ADDENDUM NO. 6

**Replace Roof and Repair Concrete & Brick
Hearnes Complex Buildings
Fulton State Hospital
Fulton, Missouri
PROJECT NO.: M1803-01**

1. SHEET A503 – Building Sections

REVISED DETAIL 1 / A503

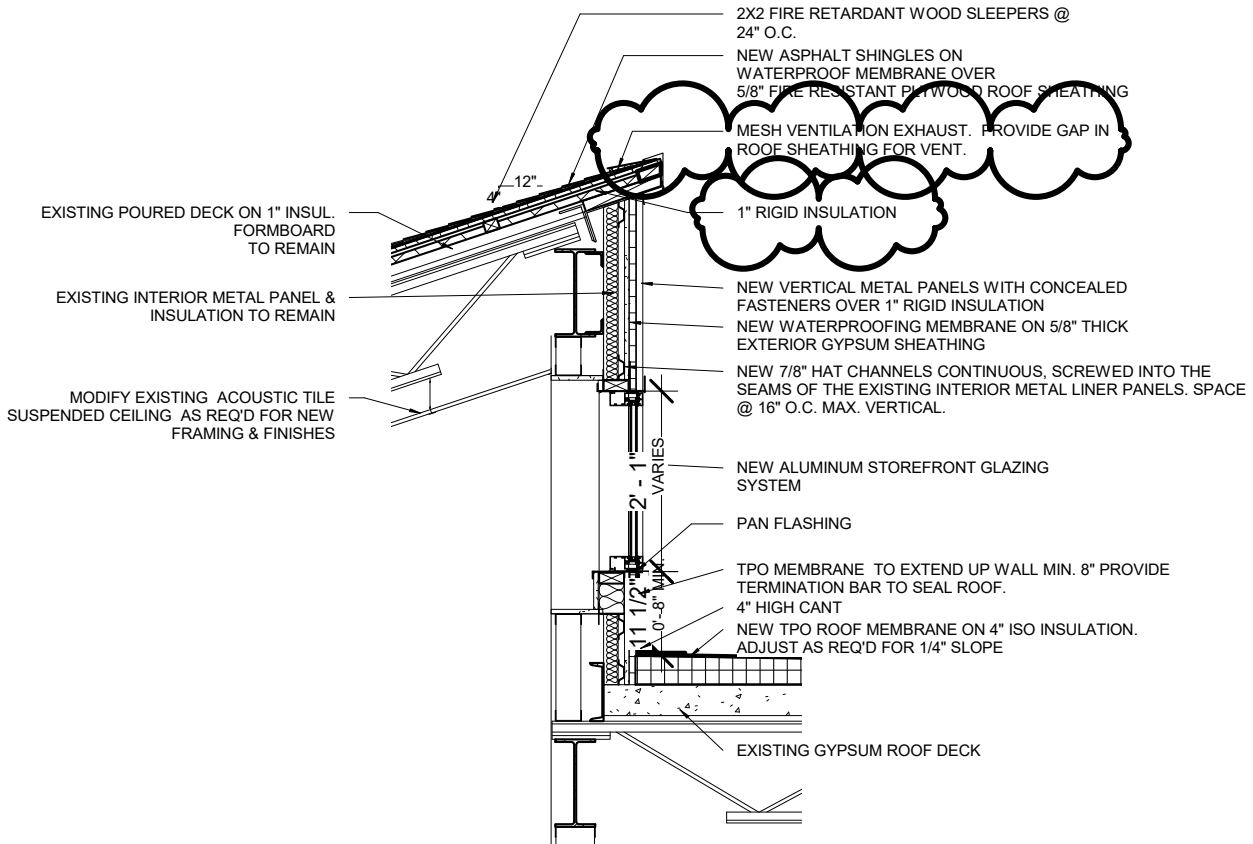
- a. REVISE Drawing A503, Detail 1/Section Through Clerestory per REVISED DETAIL 1/A503 (attached).
- b. REVISE Drawing A503, Detail 2/Section Through Clerestory W/O Window per REVISED DETAIL 2/A503 (attached).

REVISED DETAIL 2 / A504

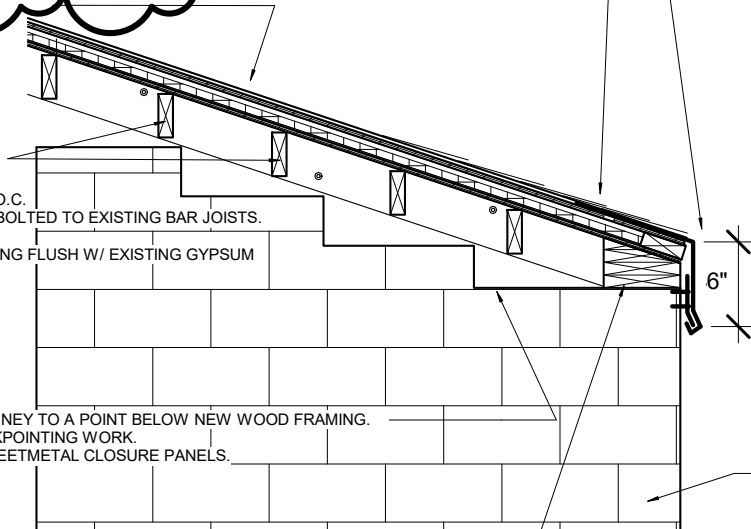
- a. REVISE Drawing A504, Detail 2/Chimney Removal Cross-Section per REVISED DETAIL 2/A504 (attached).
- b. REVISE Drawing A504, Detail 4/Clerestory Header Detail per REVISED DETAIL 4/A504 (attached).

NEW PREFINISHED METAL EDGE FLASHING OVERLAPPING EXISTING EXTERIOR MASONRY. PROVIDE ATTACHMENT CLEAT

NEW MESH VENTILATION STRIP OVER VENT SLOT IN ROOF SHEATHING

NEW SLOPED ROOF SHINGLES OVER 5/8" FIRE RETARDANT PLYWOOD ROOF SHEATHING OVER 1" RIGID INSULATION WITH 2X2 FIRE RETARDENT WOOD SLEEPERS @ 24" O.C. OVER EXISTING DECKING AND NEW FRAMED IN OPENING.

SPAN CHIMNEY OPENING W/ 2X6 FIRE RETARDANT JOISTS @ 16" O.C. ATTACH JOISTS TO NEW BLOCKING BOLTED TO EXISTING BAR JOISTS. SEE DTL. 1/A504 SET NEW FIRE RETARDANT SHEATHING FLUSH W/ EXISTING GYPSUM ROOF DECK

DEMOLISH EXISTING MASONRY CHIMNEY TO A POINT BELOW NEW WOOD FRAMING. SALVAGE BRICK FOR REUSE IN TUCKPOINTING WORK. CAP ANY OPEN FLUES W/ 24 GA. SHEETMETAL CLOSURE PANELS.

PROVIDE FIRE RETARDENT WOOD BLOCKING AS REQUIRED
